**Development Permit Panel
Electronic Meeting**

MINUTES

**Development Permit Panel
Wednesday, October 29, 2025**

For the plans involving changes to the proposed Landscape Plan, Tree Management Plan and Landscape Detail Plan, be considered to be in General Compliance with the approved Development Permit (DP 21-936427).

2. The Change in Height of North Property Line Fence from 4ft to 5ft

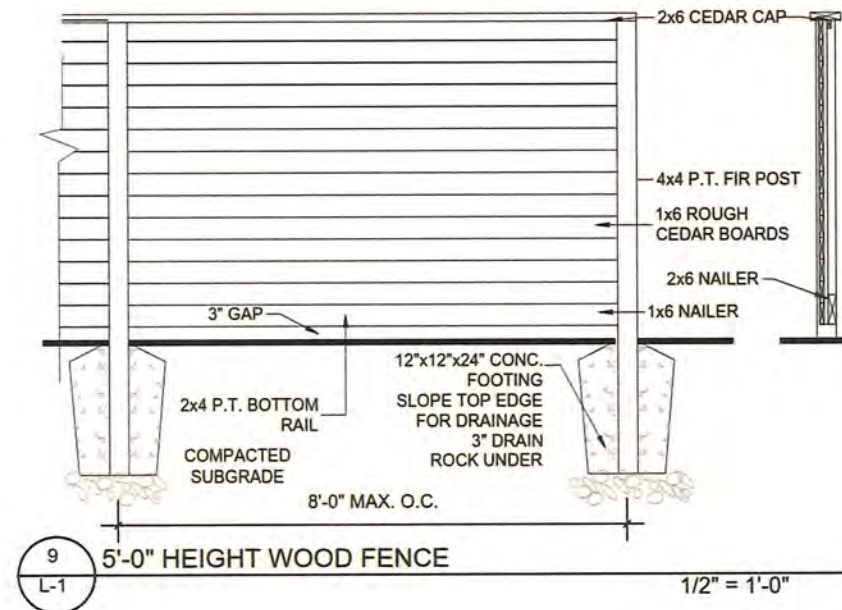
- the neighbour to the north requested that the originally planned 4ft. fence be increased for improved privacy; and
- the project team reviewed and confirmed the fence could be raised to 5ft. while remaining in full compliance with Richmond City Bylaw (combined retaining wall and fence height below 2.0m).

In response to a further query with respect to the fencing along the north property line in relationship to the front yard setback, Denitsa Dimitrova, PMG Landscape Architect, confirmed there will be a 1m high fence within the front yard setback and then the 5ft. fence extends from the end of setback beyond.

Section Drawing: 5ft Fence Height Measurement

3. The Change of East Retaining Wall Material from Allan Block to Timber

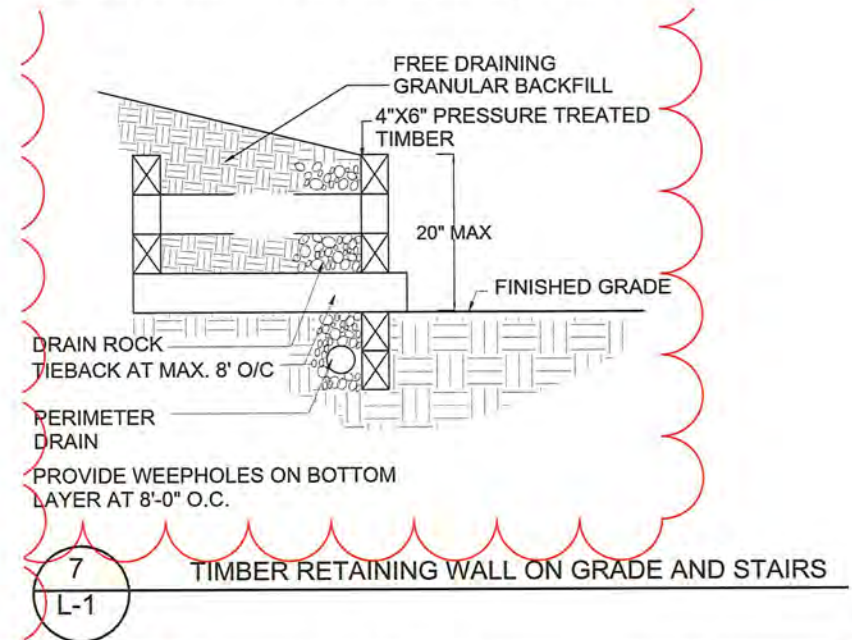
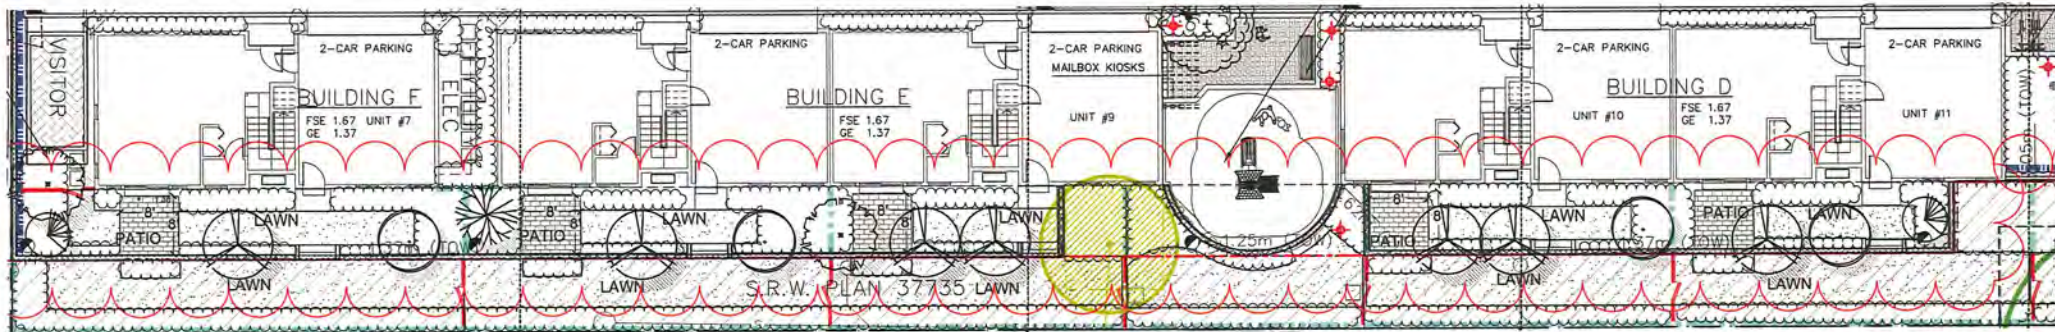
- The change in material is for the rear yards of the east side of the townhouses, with the eastern half of the backyards being within the Statutory Right-of-Way (SRW) area;
- a perimeter drain runs approximately 8 inches west of the SRW, leaving only 8 inches between the perimeter of the drain and the SRW boundary which could not accommodate 12 inch Allen Block as originally intended; and
- following discussion with the design team and Landscape Architect, a timber retaining wall (4 inches x 6 inches) is proposed instead, which has a thinner profile, will fit within the space, also provides the same durability and structural integrity and will match the wood fence style along the east property line.

- Located at the rear yards of the east-side townhouses
- The eastern half of the backyard is within the S.R.W. (Statutory Right-of-Way) area
- A perimeter drain runs approximately 8 inches west of the S.R.W. boundary
- The retaining wall is designed to be placed between the perimeter drain and the S.R.W. boundary
- The original Allan Block wall (≈12" wide) cannot fit within the 8" space
- A timber retaining wall (4"x6") is proposed instead, which fits within the space and matches the wood fence style along the east property line
